P1394a
Ft Lauderdale
December 4/5 1997

Continuous SClk Proposal

Colin Whitby-Strevens

SClk specification (Table 5-18)

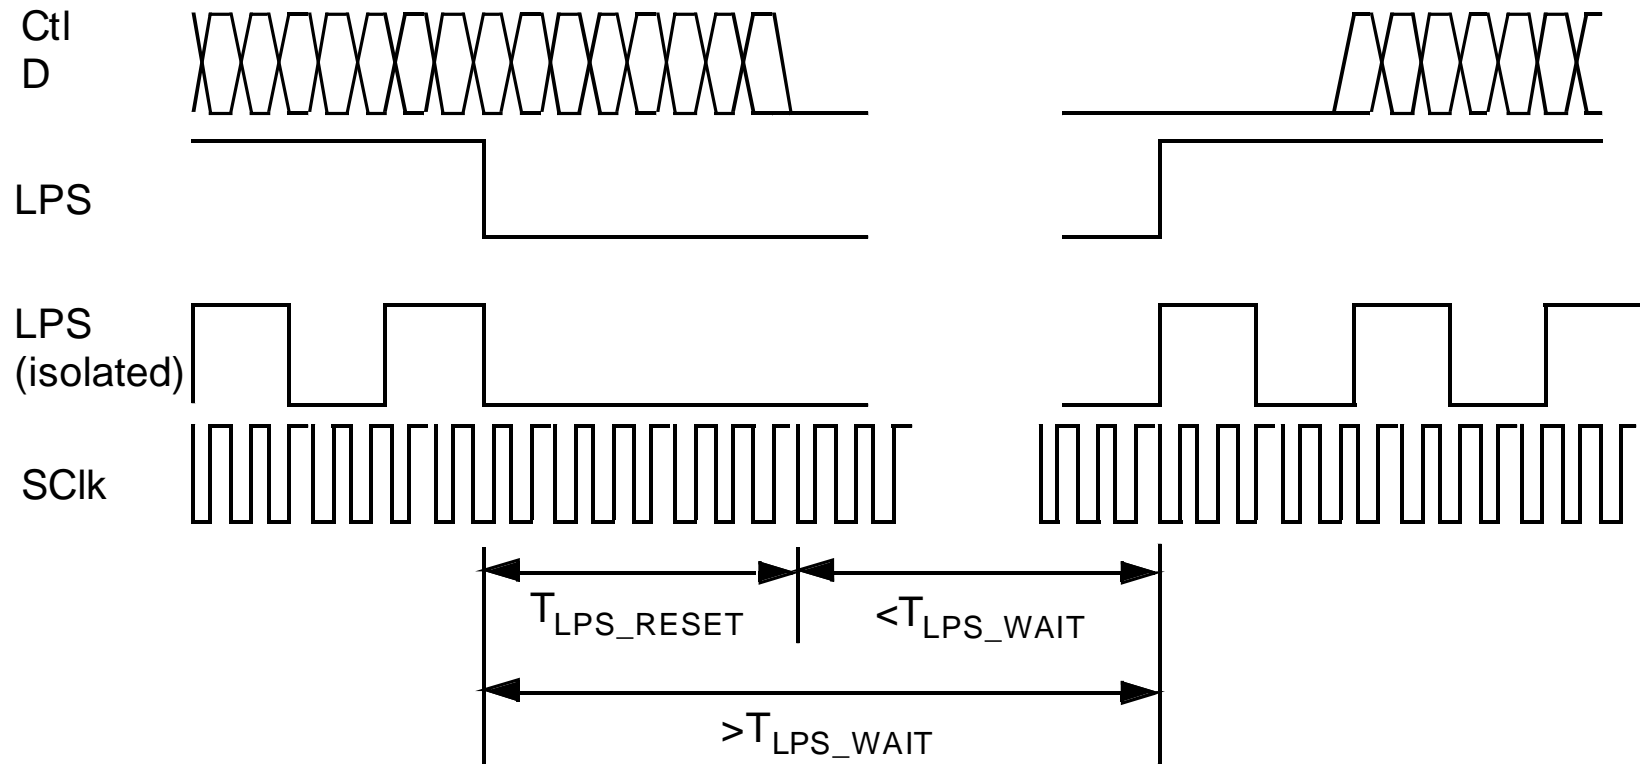
- The duty cycle is modified to 47.5%/52.5% (say)
- This increases the effective clock period for the Link/Application from 8ns to 9.5ns.
- Good thing to do anyway - and believed to be easy, maybe already true, for most/all existing PHY designs

Reset timing diagram

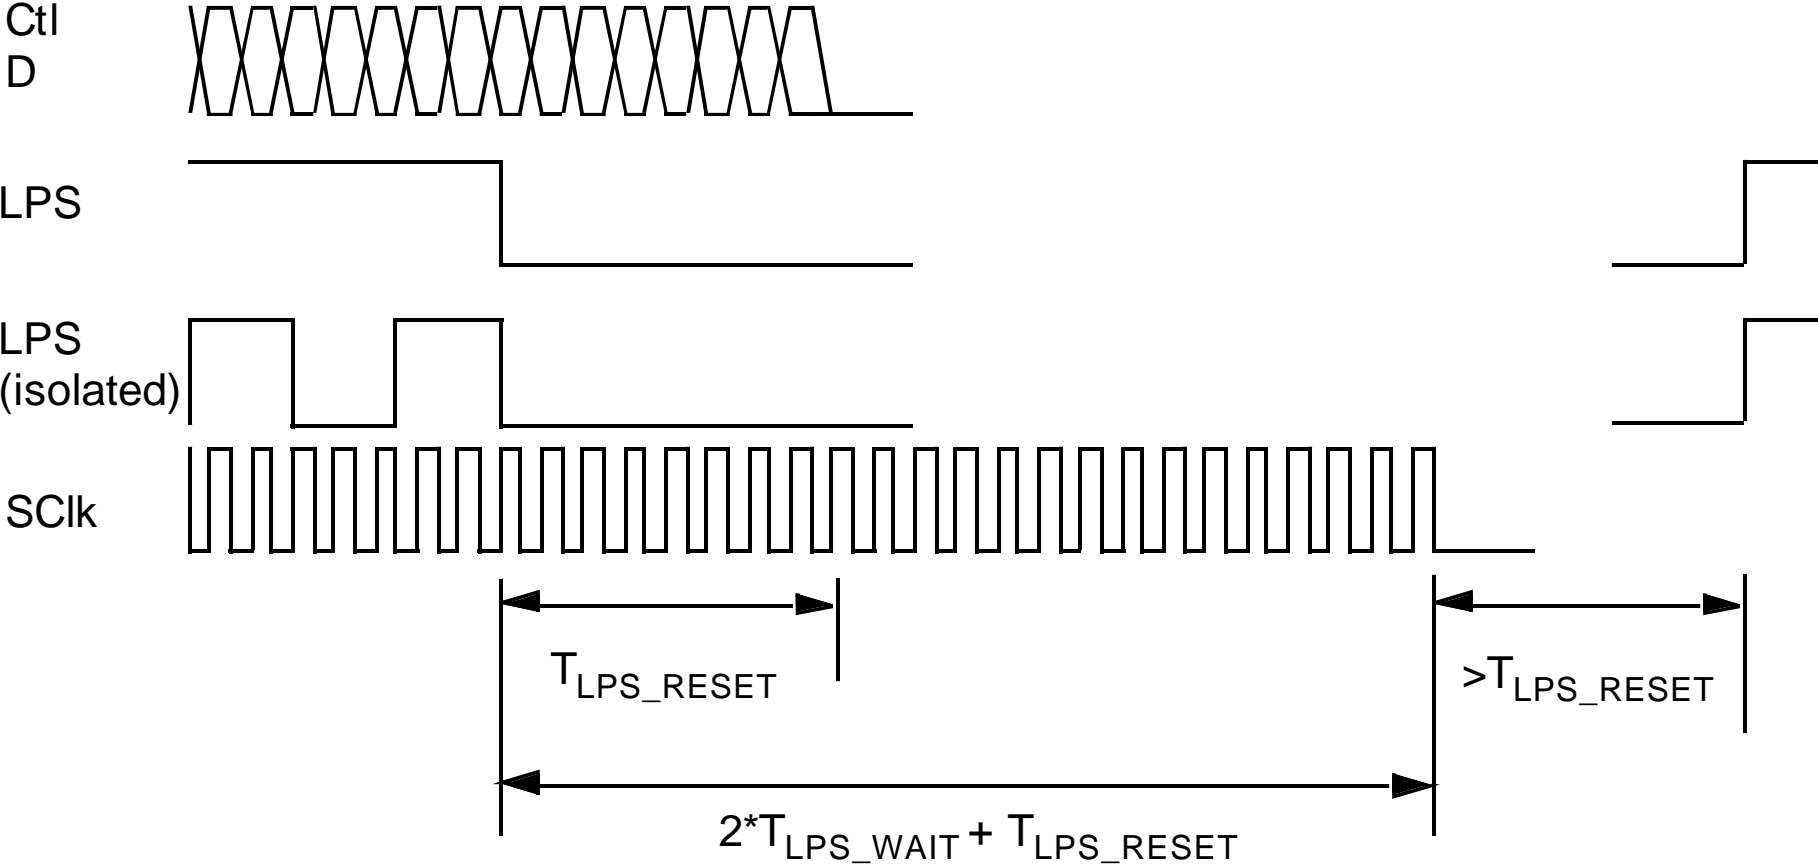
- Modify the specification of TLPS_WAIT to “LPS deassertion time”.
- Modify the minimum value for TLPS_WAIT to 12.5 us.
- Modify text to specify interface reset and interface disable separately
- Modify reset timing diagram and add new disable timing diagram
- Define power reset
